**FINAL WORK PLAN  
PILOT-SCALE EVALUATION OF  
HYDROGEN RELEASE COMPOUND  
FOR ENHANCED IN-SITU BIOREMEDIATION AT AOC 50**

**DEVENS RESERVE FORCES TRAINING AREA  
DEVENS, MASSACHUSETTS**

**RESPONSE TO COMMENTS**

**DRAFT WORK PLAN  
PILOT SCALE EVALUATION OF HYDROGEN RELEASE COMPOUND  
FOR ENHANCED NATURAL ATTENUATION AT AOC 50**

**FIGURE 2**  
**DISTRIBUTION OF PCE IN GROUNDWATER ALONG CROSS SECTION A-A'**  
**ENHANCED IN-SITU BIOREMEDIATION PILOT STUDY**  
**DEVENS RESERVE FORCES TRAINING AREA**  
**DEVENS, MA**

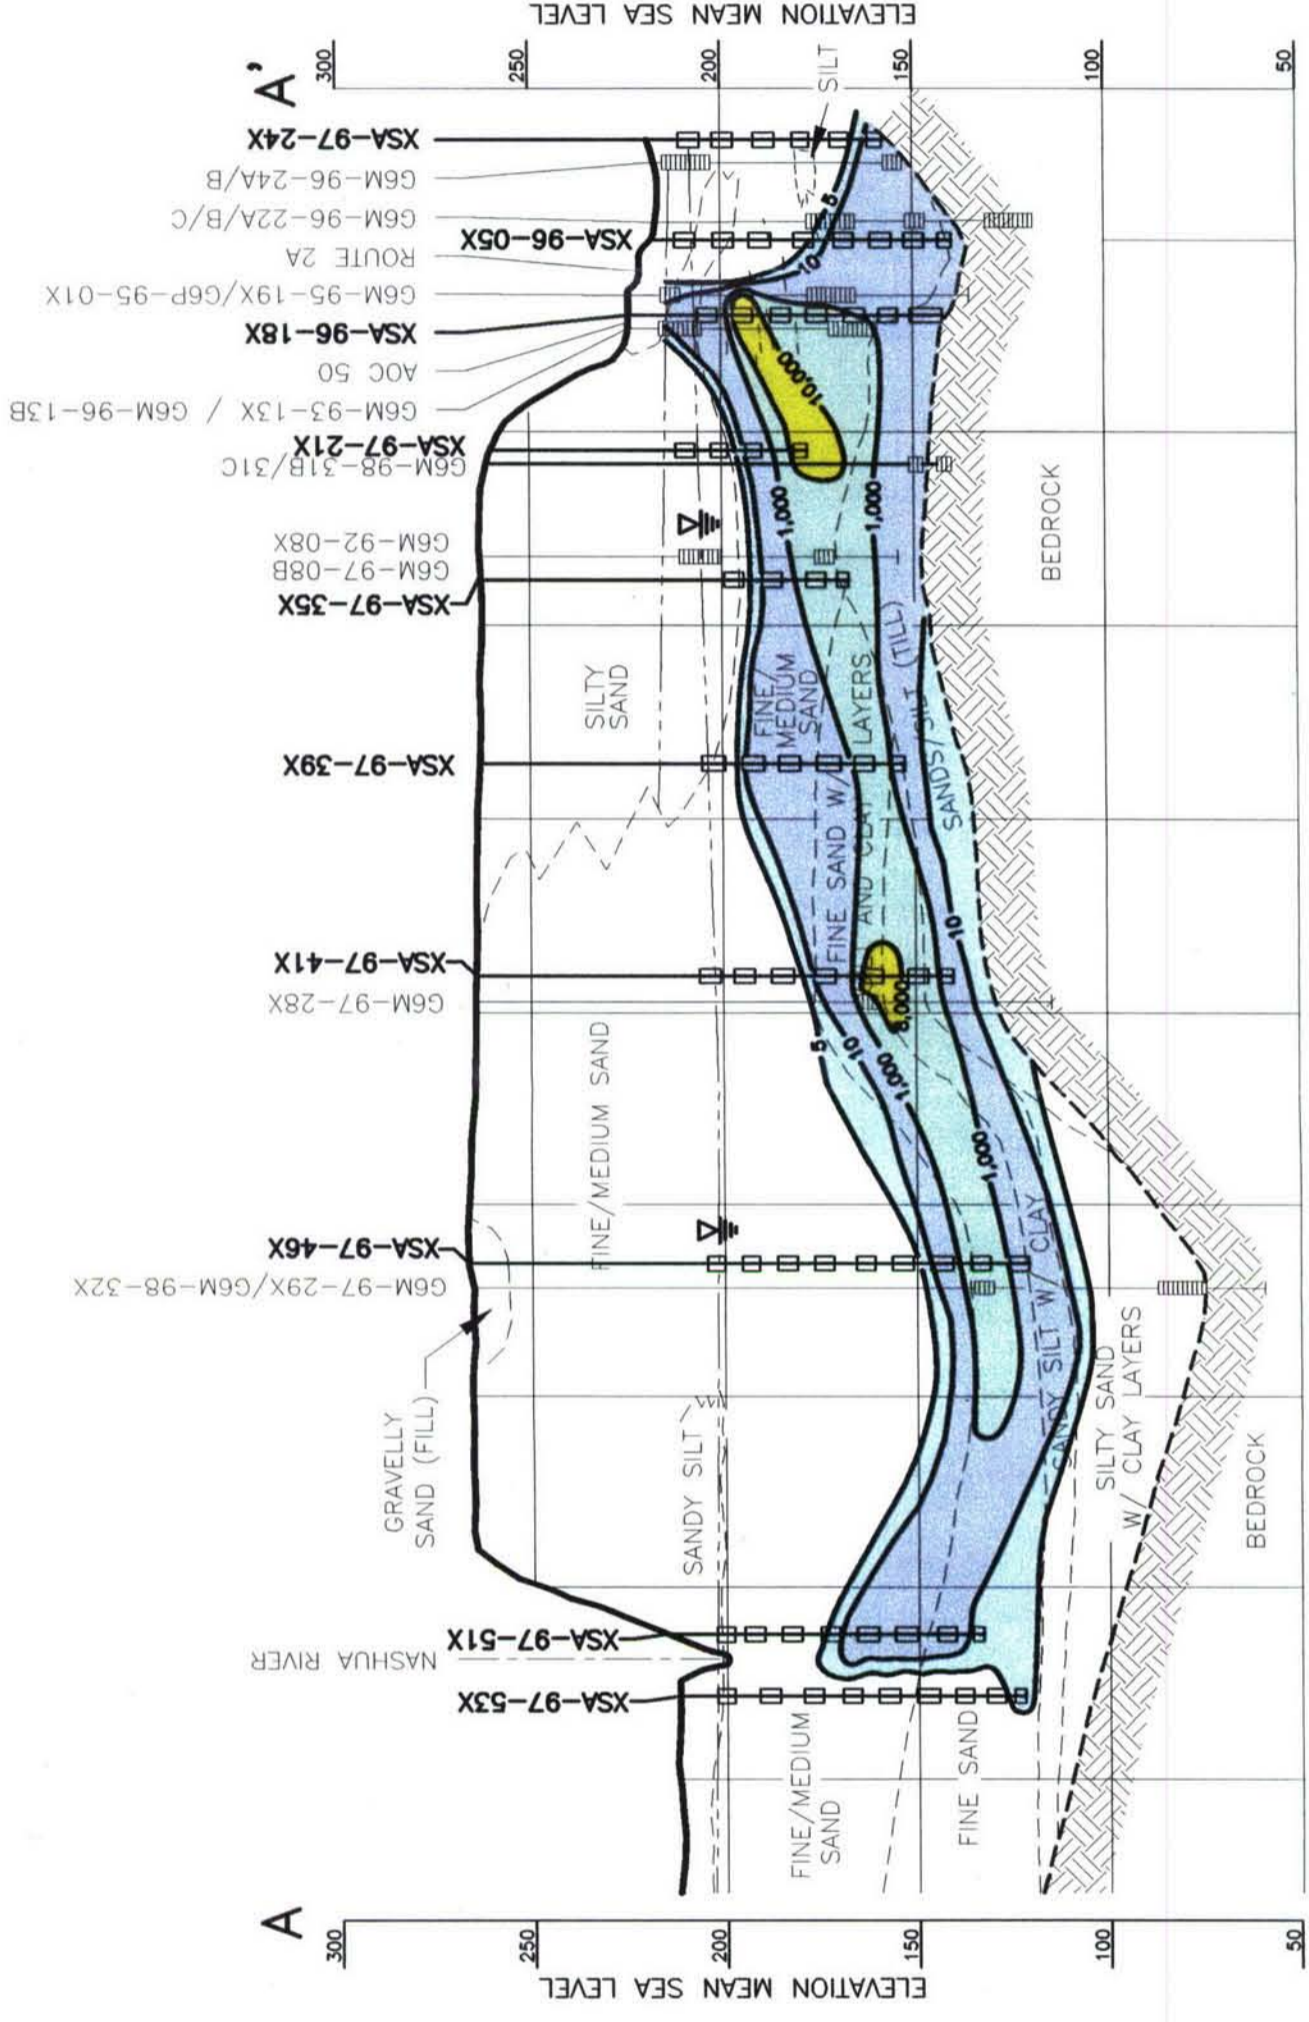
**MADEP Comment No. 2; Section 4.2 HRC™ Injection:** The Plan calls for injecting HRC™ over an interval of 140 to 120 feet below ground surface (ft-bgs) in the vicinity of XGM-98-32X. A review of the Figure 2 Distribution of PCE in Groundwater Along Cross Section A-A' shows the vertical distribution of the PCE plume to be from a depth of 115 to 160 ft-bgs. While the upper limit of the proposed injection interval appears to be proximal to the upper limit of the PCE distribution, the lower limit coincides with the lower PCE 1,000-ug/l concentration contour.

MADEP understands that interpreted geologic conditions at depth in this area consist of finer materials than that in the center or upper portions of the plume. However, these conditions based on the geologic history and boring logs, show a stratification of coarser and finer materials through which groundwater flow is predominantly horizontal. Historically, PCE has on one occasion been detected at depth in G6M-97-29X, which is placed with the screen just above bedrock. However, MADEP understands that the Army attributes the PCE detection to laboratory or sampling and handling error. The presence of PCE in this geologic media would likely be attributed to groundwater entering from an upgradient location, as opposed to vertical dispersion from above. Therefore, the HRC™ injected in a zone above will unlikely provide a beneficial impact to groundwater within or below this area. Therefore, MADEP recommends that the Army and its consultant evaluate the necessity of extending the vertical HRC™ injection interval deeper. Please provide a discussion for the selection of the HRC™ injection interval not to extend deeper into the aquifer to encompass more of the plume.

**Response:** The objectives of the pilot test are to assess whether conditions suitable for anaerobic degradation of PCE can be induced and to better characterize several process variables. Injection across the full thickness of the plume is not necessary to do this. There is no supposition that injection at the 120 to 140 ft bgs interval will treat groundwater at the 180 ft bgs depth of the G6M-97-29X screen.

**FIGURE 4**  
**HRC PILOT TEST LAYOUT**  
**ENHANCED IN-SITU BIOREMEDIATION PILOT STUDY**  
**DEVENS RESERVE FORCES TRAINING AREA**  
**DEVENS, MA**

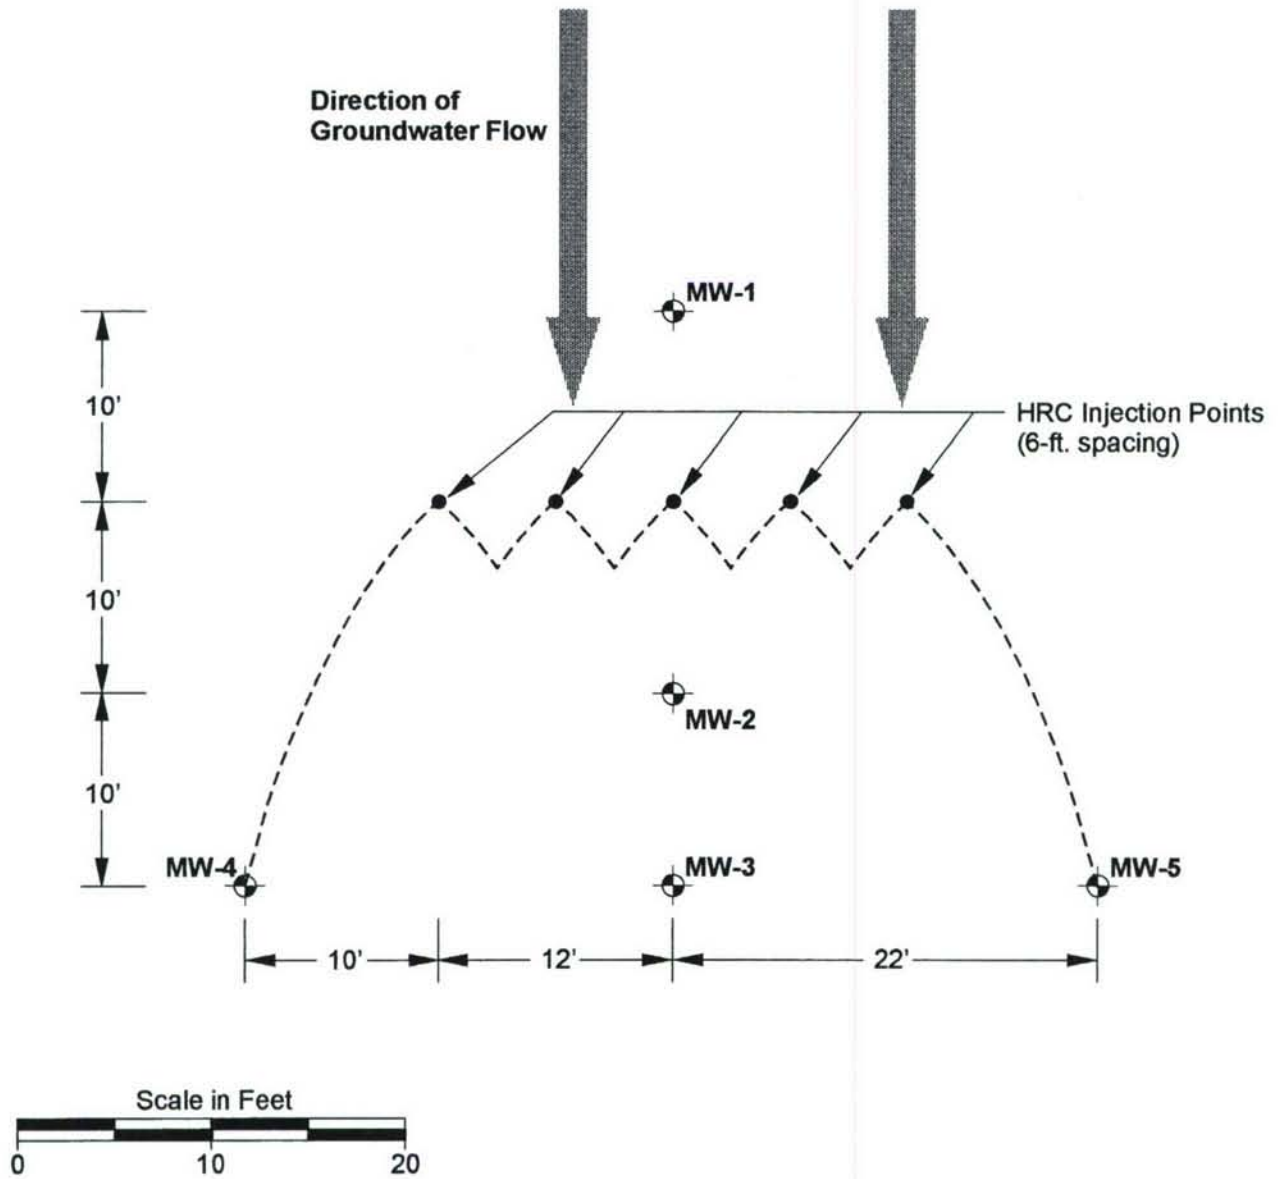
**USEPA Comment No. 9; Figure 4:** Two additional upgradient wells along a line parallel to the HRC injection points and intersecting well MW-1 should be included in this figure so as to completely assess the upgradient contaminant profile prior to groundwater entering the HRC treatment zone. The upgradient and downgradient monitoring wells and HRC injection points shown in Figure 4 should also be superimposed on Figures 1, 2, and 3 to show the plan view collocation of the HRC pilot test with the existing wells and PCE plume and to show in the vertical profile the depth of the well screens on those monitoring wells used in the pilot test. For example, one cannot know where well GM-98-32x is located in relation to the proposed monitoring wells and HRC injection points.

**Response:** Although more monitoring wells would provide increased contaminant profiling of upgradient groundwater, it is believed that the objectives of the pilot test can be met with the proposed monitoring wells. Groundwater samples will be collected from all the monitoring wells according to the schedule in Table 2. Considering the closeness of the monitoring wells (i.e., five wells in a 30- by 44-ft area), groundwater within the treatment zone should be well characterized. Further, limiting the number of monitoring wells will limit the disturbance of aquifer materials and potential introduction of drilling water.

The network of injection points and monitoring wells shown in Figure 4 will be located immediately north of G6M-98-32X and the service road that runs along the southwest edge of MAAF.
